STAFF REPORT

APPLICATION PRC 76-C-111

SOUTH LAKES HIGH SCHOOL ADDITION

PRC PLAN
PRC 76-C-111
 HUNTER MILL DISTRICT
 FAIRFAX COUNTY, VIRGINIA
 APRIL 10, 2015

PRC PLAN

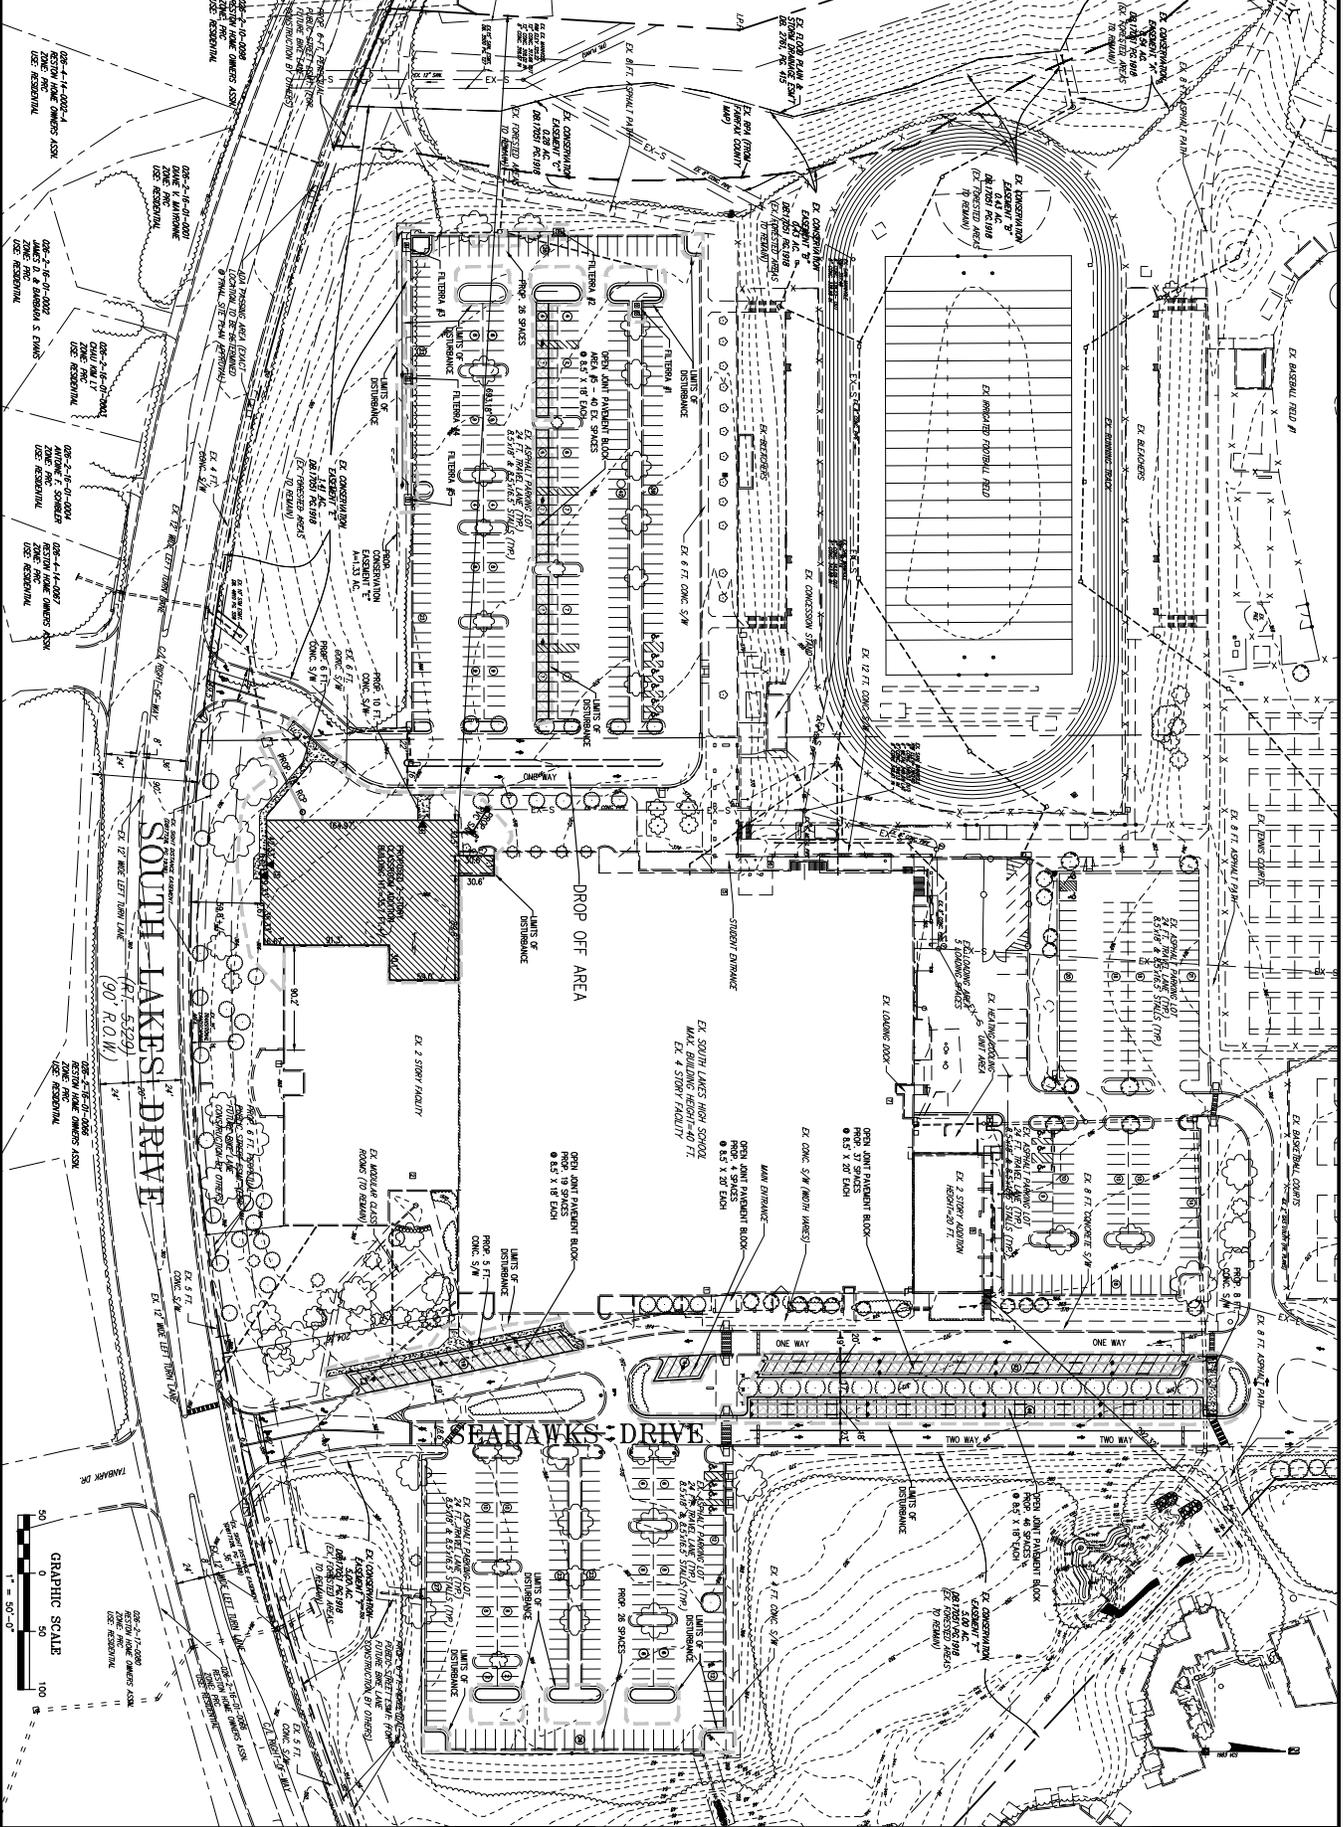
The drive aisles depicted on the applicant's initial plan submission for Seahawks Drive did not meet the drive aisle width requirements of the Public Facilities Manual (PFM), which requires 23-foot wide drive aisles for both one-way and two-way travel aisles when parking spaces at 90 degrees are located along the drive aisles. Staff requested that the applicant revise the plans to meet the PFM requirements. The applicant responded by revising the plans to show a 23-foot wide travel aisle where the

proposed 90 degree parking is located on the eastern side of the median along Seahawks Drive. The revised plans depict angled parking on the western side of Seahawks Drive with a drive aisle width of 19 feet, which meets the PFM travel aisle width requirements for a one-way travel aisle with angled parking.
